BLAENAU GWENT COUNTY BOROUGH COUNCIL	
Report to	The Chair and Members of Planning, Regulatory and General Licensing
Report Subject	Planning Applications Report
Report Author	Team Manager Development Management
Report Date	25th January 2021
Directorate	Regeneration & Community Services
Date of meeting	4th February 2021

Planning Report

Application No:	App Type: Resubmission
Applicant: Mr Mark Harris Nags Head Merthyr Road Tredegar NP22 3AP	Agent: Mr Adrian Drew 14 Thornhill Close Brynmawr NP23 4SA
Site Address: Garden of the Nag's Head Merthyr Road, Tafarnaubach, Tredegar	
Development: New house build	
Case Officer:	Jane Engel

Figure 2 : Block Plan

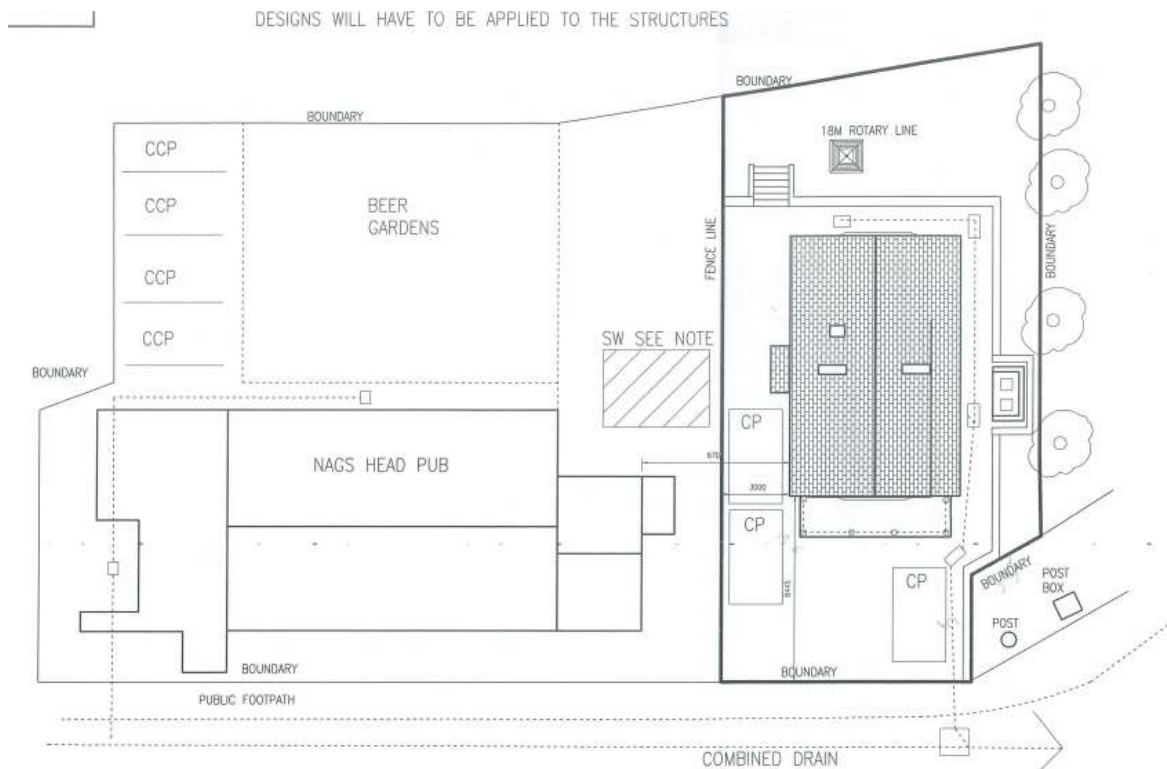
5.4	<p>The proposed block plan indicates that an area to the rear/north of the existing public house (currently identified as a private garden) will be used as a beer garden. This will be to displace the beer garden currently identified on the land where the new house is to be erected.</p>

5.5	<p>The block plan also indicates that the new dwelling (discounting the ground floor single storey projection) will be positioned approximately 8.5metres back from the front site boundary. This means the house will be will be set back approximately 6.0metres behind the building line established by the existing public house. The block plan also proposes that the area in front of the house would accommodate one car parking space and that an area to the side/west of the new house would accommodate a further two parking spaces. Such provision meets the highways authority requirements for a dwelling of the design proposed.</p>

5.6	<p>I further note that the footprint of the proposed house will mean that only a small remaining area of land to the rear/north of the property will be available as amenity area to serve what would be a large 4/5 bedroomed house. I recognize however that the balcony area currently proposed above the ground floor projection on the front of the property would also provide a small separate amenity area for the benefit of the occupants. Whilst I am mindful that the overall amenity area available for occupants of a dwelling of the size proposed will be limited I do not feel that the proposed footprint of the dwelling constitutes overdevelopment which might justify refusal of the application</p>

Figure 4 : Elevations

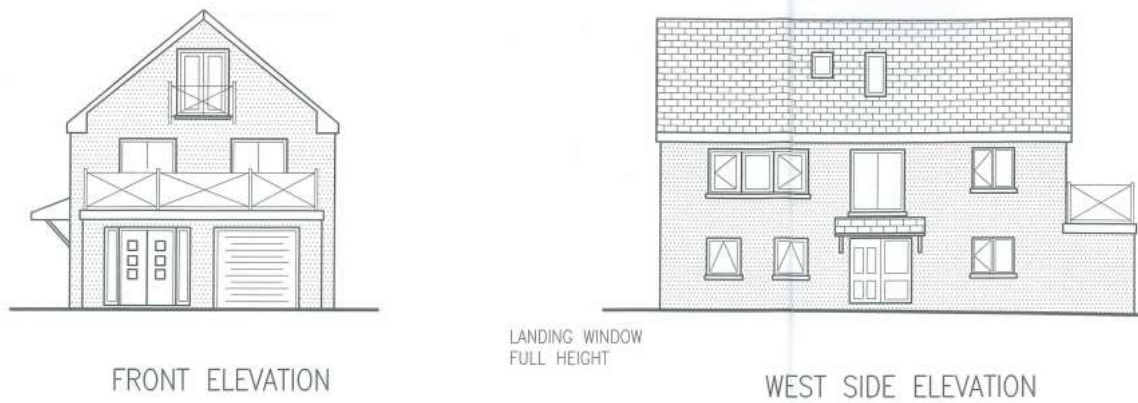
5.9 Undoubtedly this house is of a non-traditional design and would be in stark contrast with the design of other properties in the locality. Whilst this is not of itself a reason to object to the development, having regard to what were considered legitimate design concerns the applicant was asked to make changes that may have resulted in a form of development that could be supported e.g. bringing the property forward to better align with the existing public house; turning the roof in order that the ridge runs parallel with the road and other properties in the area and revising the floor layout and rationalizing and removing some window and door openings on the side of the property facing the public house (and beer garden) to address amenity/compatibility concerns. Despite having been advised of such concerns in relation to the withdrawn application the applicant has chosen to submit what is a largely unaltered scheme for determination

Whilst the fact that the proposed dwelling is of a non-traditional design is not of itself a reason refuse a planning application LDP policy DM1.2 b clearly requires that new development should have *no unacceptable adverse visual impact on townscape or landscape*, policy DM2(a) states that development *proposals should be appropriate to the local context in terms of type and form, scale and mix* and Policy DM2 (b) requires proposals to be *of a good design which reinforces local character and distinctiveness or positively contribute to the area's transformation*. In my opinion the proposed dwelling fails to meet all of these requirements.

Figure : 5 Floor Plan

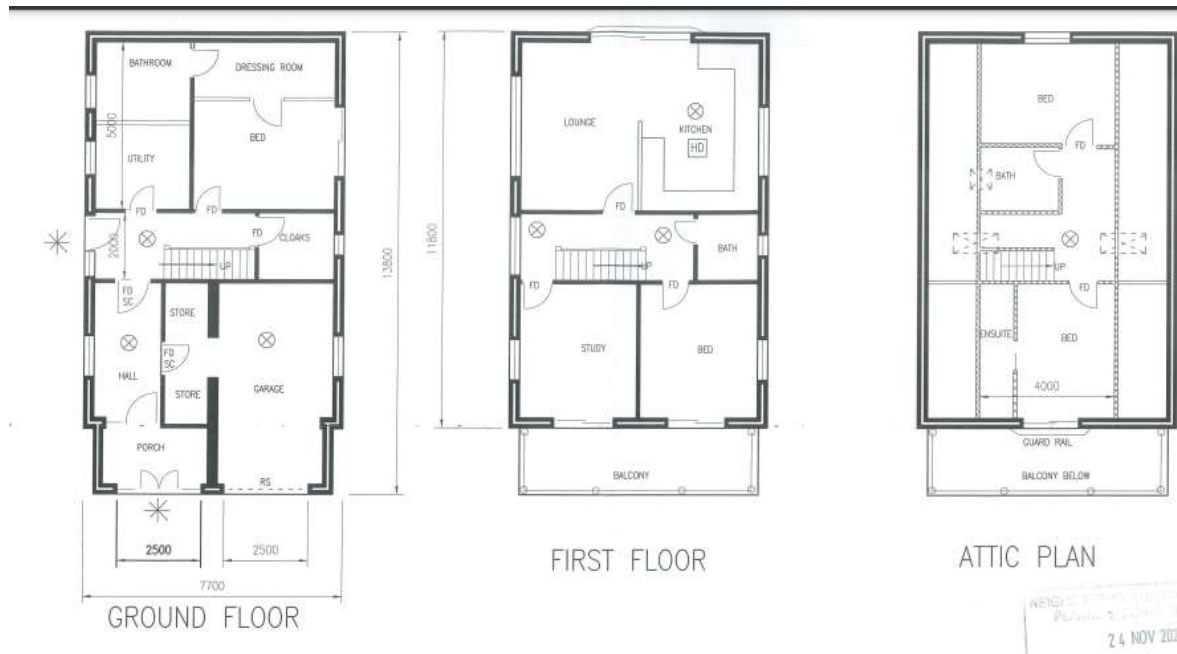
Having considered the siting/scale issues noted above detailed consideration has also been given to the design of the proposed dwelling and its potential impact of the visual amenity of the area. Members will note from the elevation details provided below that the dwelling proposed is a substantial three storey property with a gable facing the road. The south facing front elevation and the west facing side elevation will feature a large number of window and door openings serving a range of habitable rooms and the front elevation features a flat roofed front projection which provides a balcony area that can be accessed from a first floor study and bedroom.
